PROJECT: P&ID LABORATORY HVAC REFRIGERATION SYSTEM (RG)

CLIENT: WM. H. ZIMMER NUCLEAR POWER STATION UNIT

DRAWING NO. M-97 SH. 2 OF 3

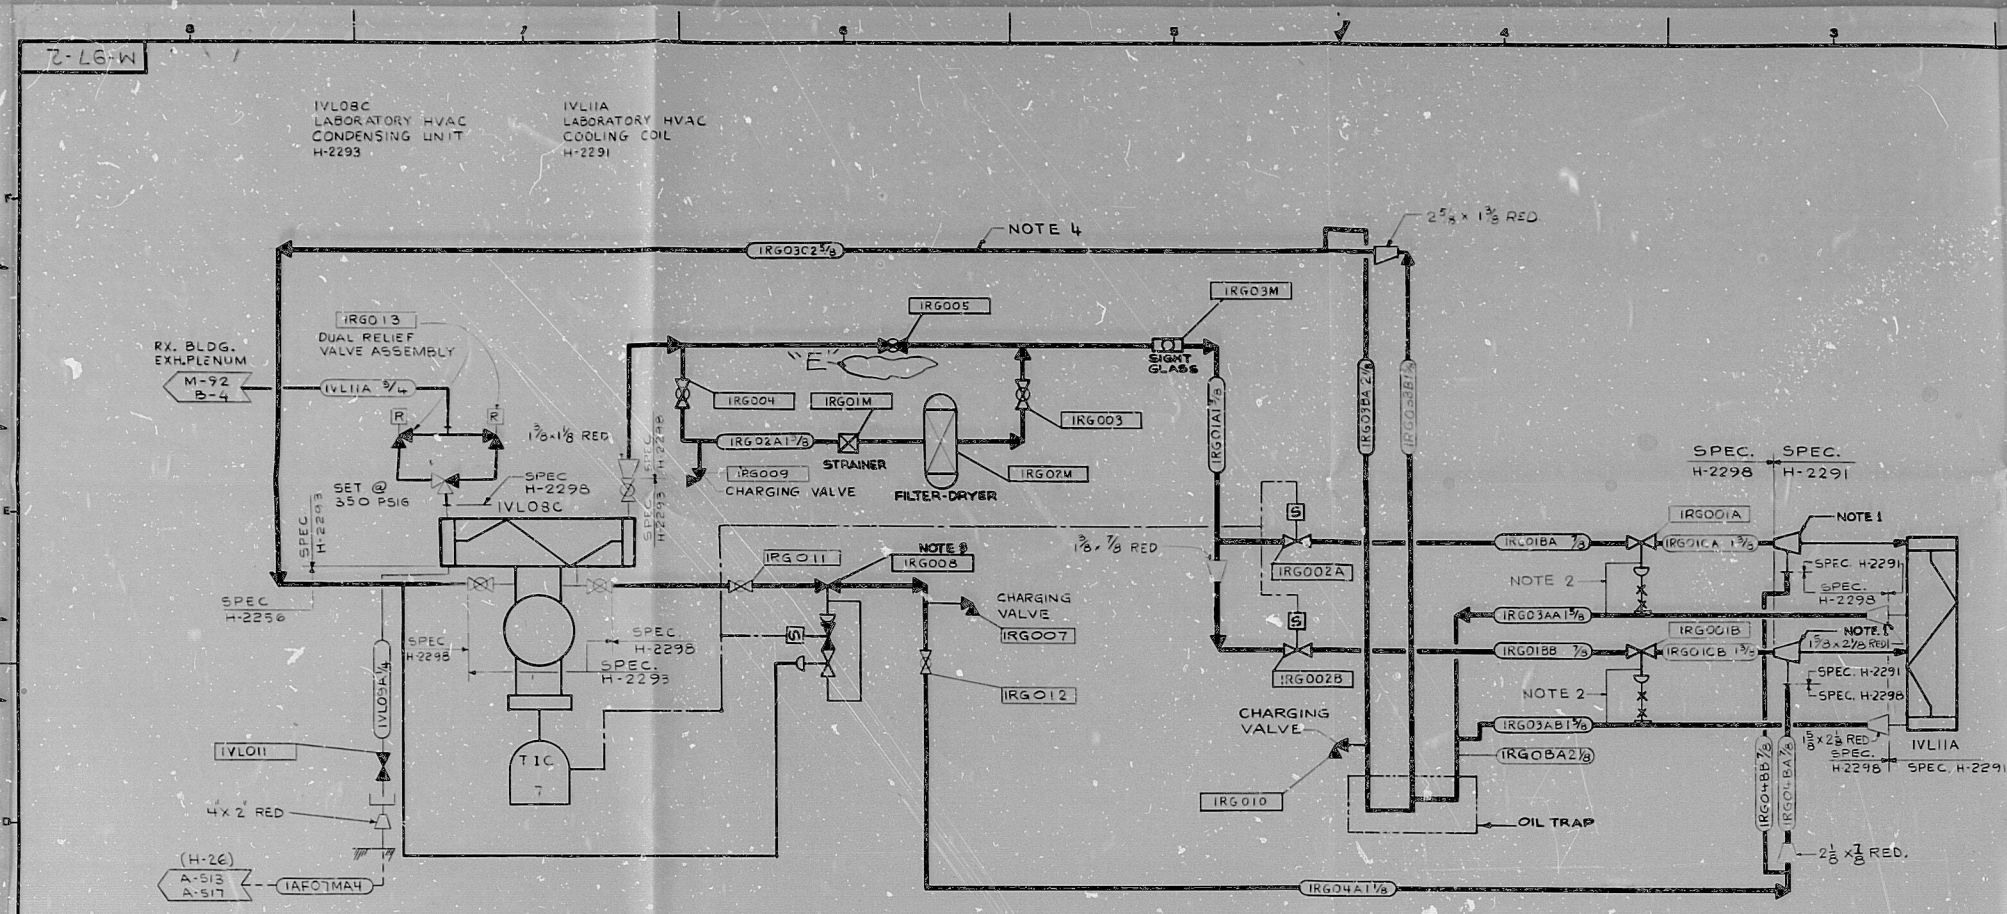
REV. "E"

1. REMOVED "LC" FROM VALVE IRG005.

PER MT. 511.
